Giant Mine Environmental Assessment

Round One: Information Request - Review Board #04

INFORMATION REQUEST RESPONSE

Information Request No: Review Board #04

Figure 1 Unfrozen volumetric water content curves on arsenic trioxide samples for different degrees of saturation¹.

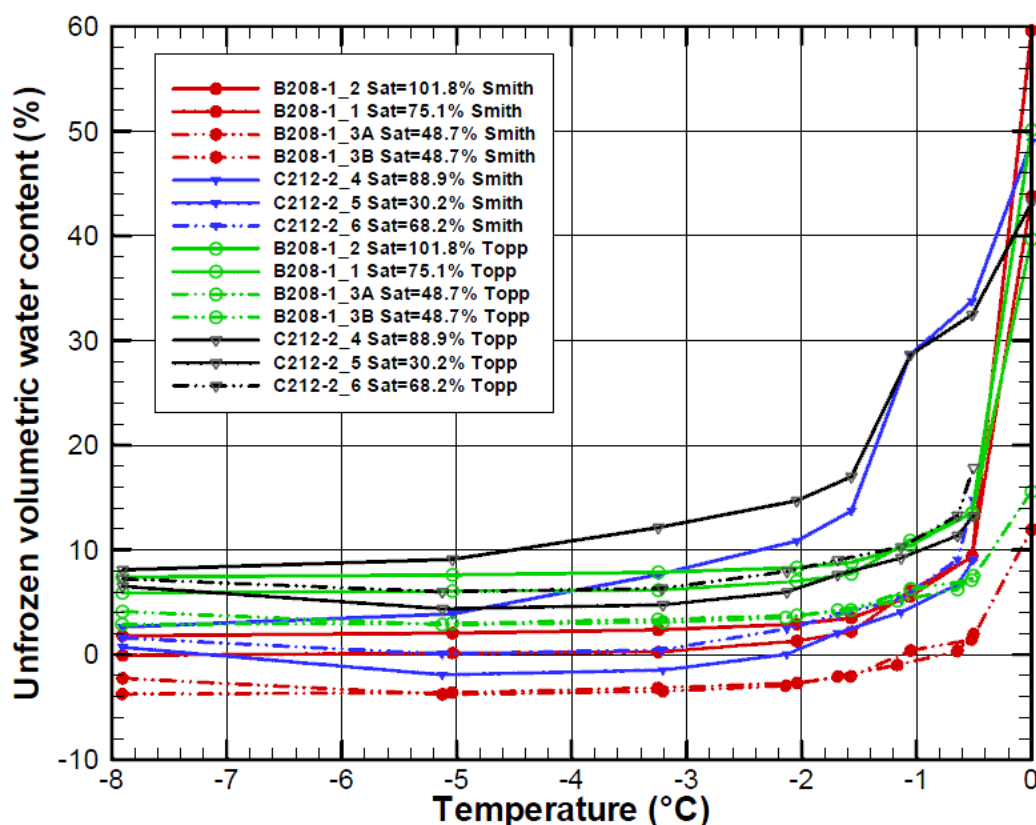
However, the DAR does not present a detailed assessment on temperature dependent hydraulic or thermal conductivities and does not seem to consider that the phase change is likely at a range different than the stated -1°C to just above 0°C. Laboratory tests presented by SRK (Memo entitled: "Physical properties of overburden, bedrock and arsenic dust", 5.9.2005) show that at temperatures of -8°C, the unfrozen water content can be as high as 8 Vol.-%, which affects its hydraulic permeability. In addition, a chemical rejection is to be expected, potentially changing the arsenic trioxide concentration as the chambers freeze, further affecting the freezing point of the ground.

1. Please clarify
 - a) the potential of change in freezing point depression as a function of freezing rate;
 - b) the factor of safety associated with the -5°C criterion and point of completely frozen conditions (no unfrozen water present);
 - c) the change in hydraulic permeability as a function of negative temperature and degree of saturation;
 - d) the assessment of the potential seepage through the frozen block assuming best estimates for the frozen hydraulic permeability; and
 - e) the use of the term “thaw” within the DAR and a clear definition, which preferentially is defined on an acceptable hydraulic permeability, hence unfrozen water content

Figure 1 of the 'Physical properties of overburden, bedrock and arsenic dust' memo, below, shows the unfrozen volumetric water content curves on arsenic trioxide samples for different degrees of saturation. Between temperatures of -5°C and -8°C (temperatures at which tests were completed), there was very little change in the unfrozen water content. The -5°C criterion was chosen as there is very little additional benefit gained by cooling the arsenic dust below this temperature. It should be noted the unfrozen water content (ranging from 0 to 9% in the tests) will largely be bound by ice and immobile, in addition to being encapsulated by the frozen bedrock shell.

The term thaw is used in the DAR to refer to the transition between frozen and unfrozen conditions. For the arsenic trioxide, as shown in the figure presented above, this transition largely occurs between -0.7 °C and 0 °C. For the bedrock material, no unfrozen water content testing was completed. In the thermal modeling simulations described in the Conceptual Engineering for Ground Freezing report, phase change was assumed to occur between temperature of -0.5 °C and -0.1 °C.
